CITY OF MEXICO BEACH
4TH STREET STORMWATER IMPROVEMENTS PROJECT

**ADDENDUM NO. 3
REQUESTS FOR INFORMATION**

Issued August 27, 2025

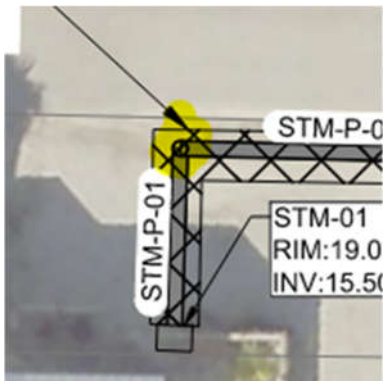
3. What are you needing in this highlighted area?

City's Response to Request for Information Question No. 3: Refer to revised drawings included as Attachment C.

4TH STREET IMPROVEMENTS PLAN
4TH STREET STORMWATER IMPROVEMENTS
 MEXICO BEACH / BAY COUNTY / FL
 THIS SHEET NOT VALID FOR CONSTRUCTION WITHOUT COMPLETE SET OF PLANS. SEE GENERAL NOTES FOR MASTER LEGEND.
 Sheet No. **C1.0**

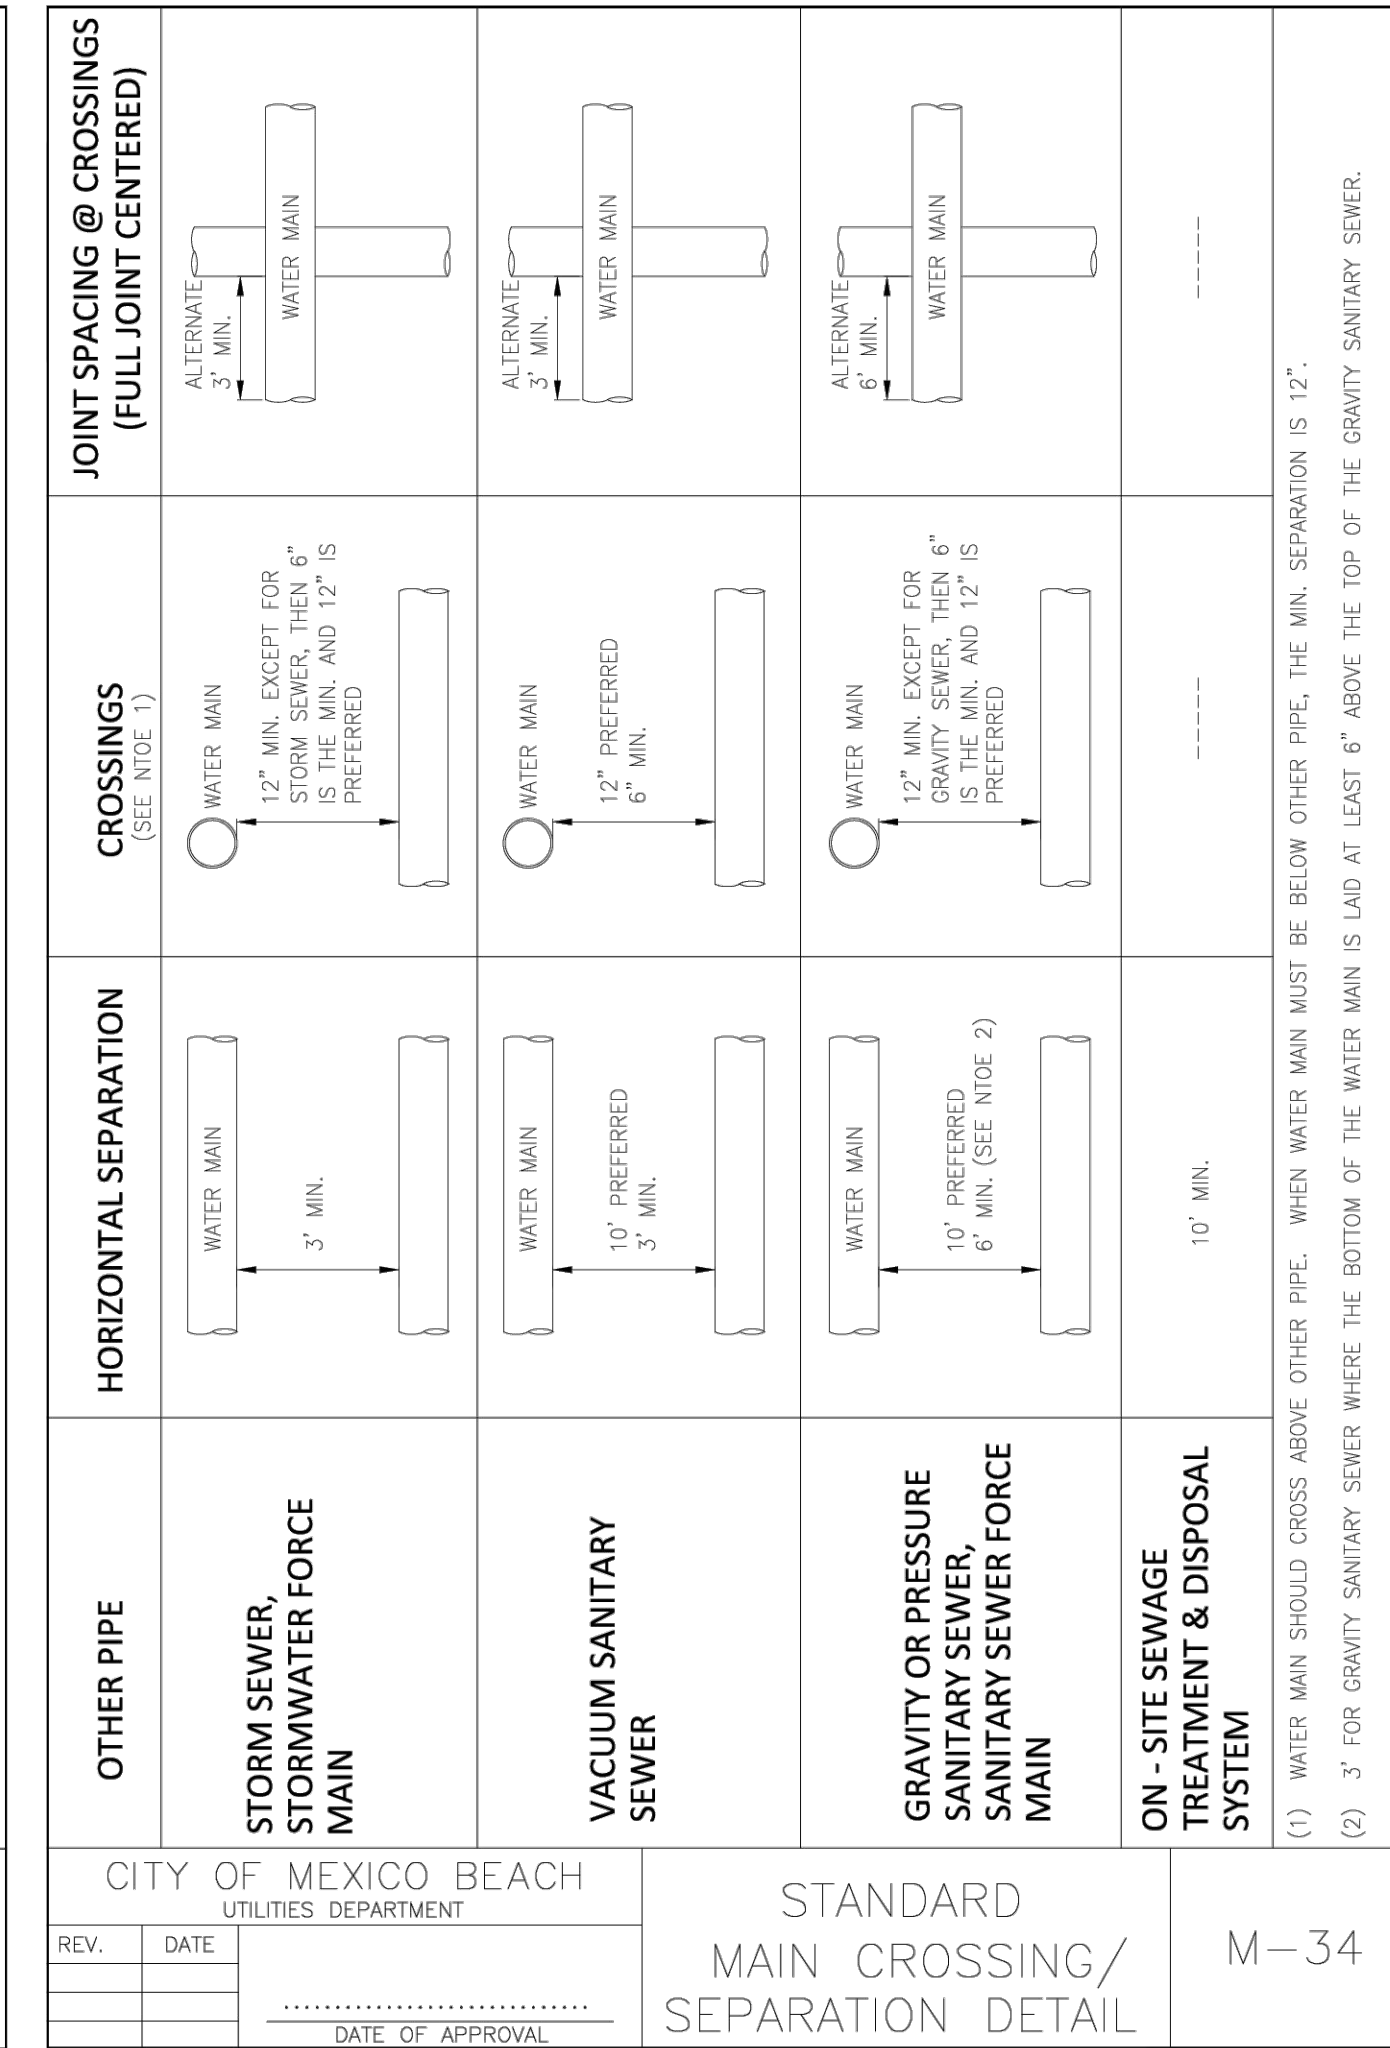
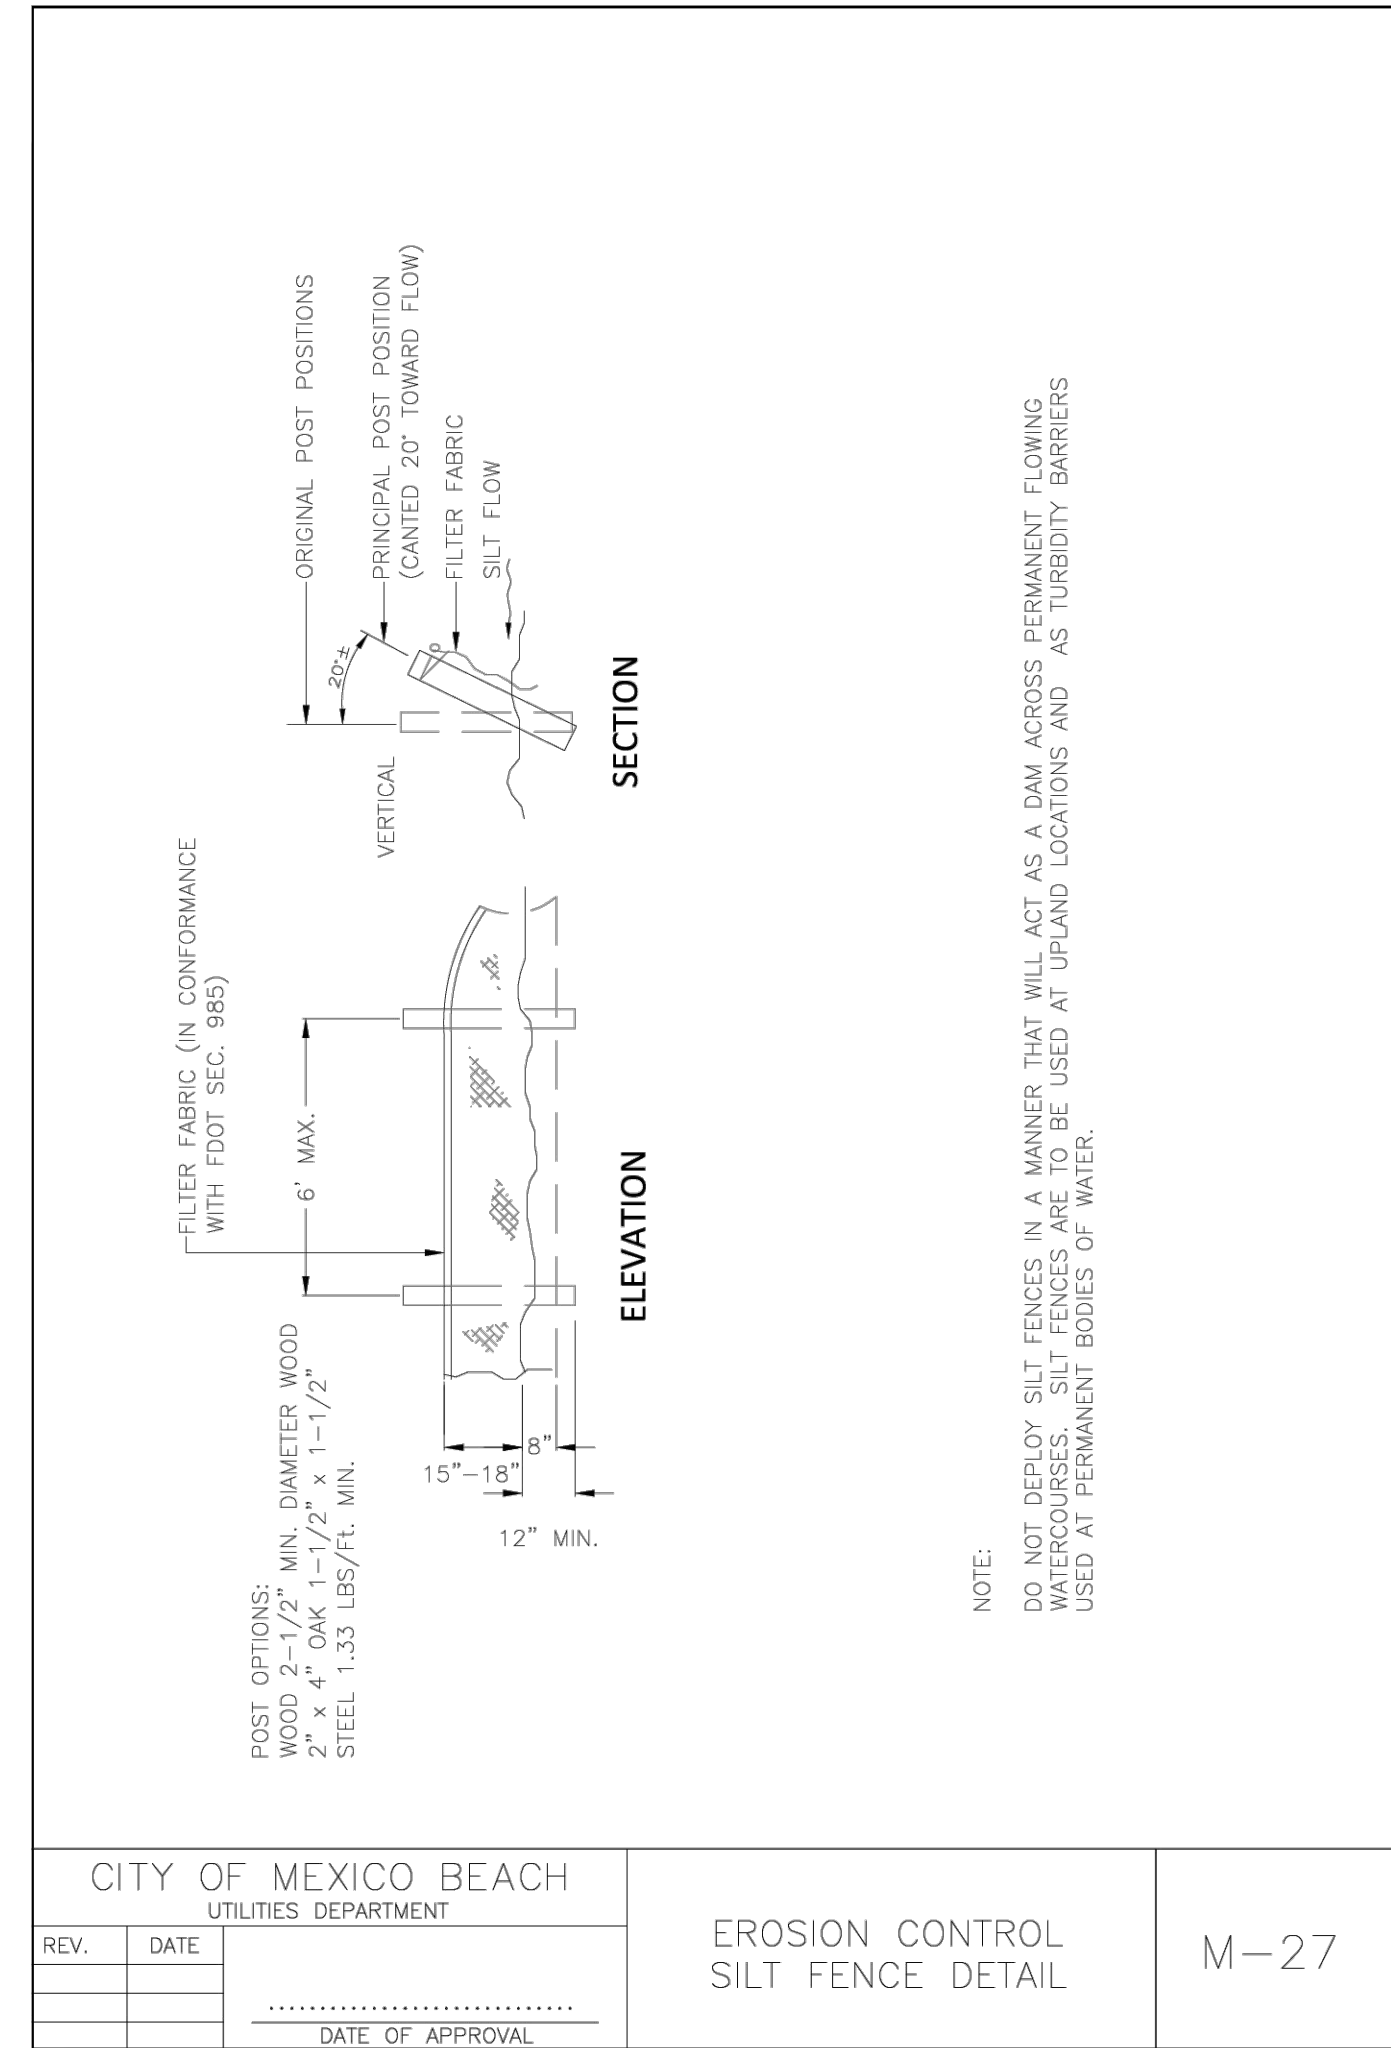
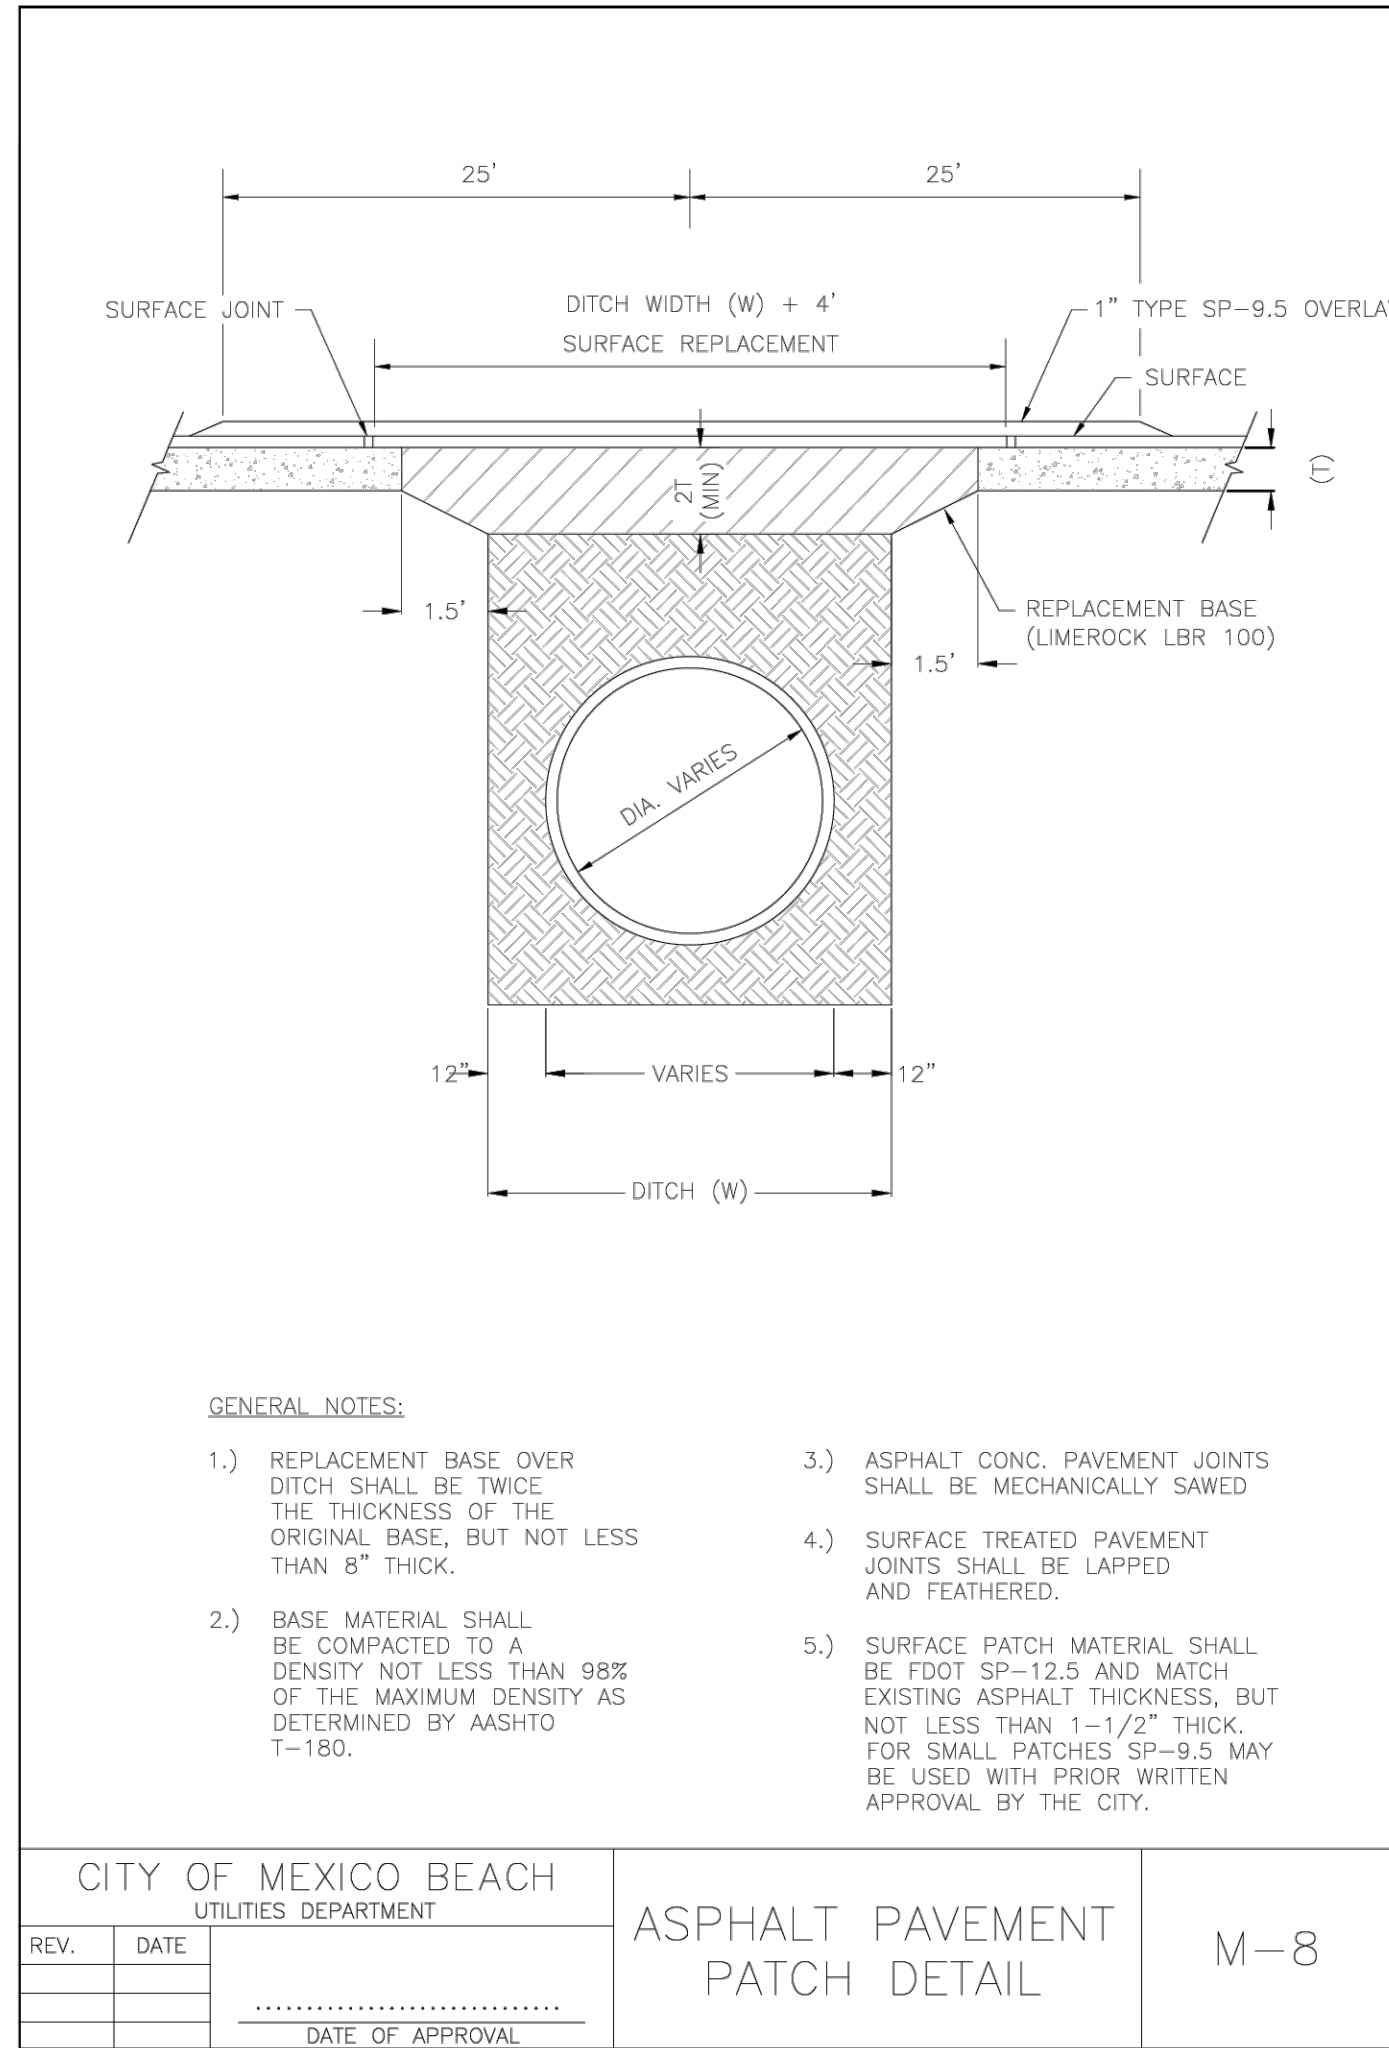
2. On sheet C1.0 between STM-P-01 and STM—02 the new storm pipe makes a 90 degree turn from the right of way to STM-P-01. It is unclear how you propose this turn. Please advise.

City's Response to Request for Information Question No. 2: Refer to revised drawings included as Attachment C.
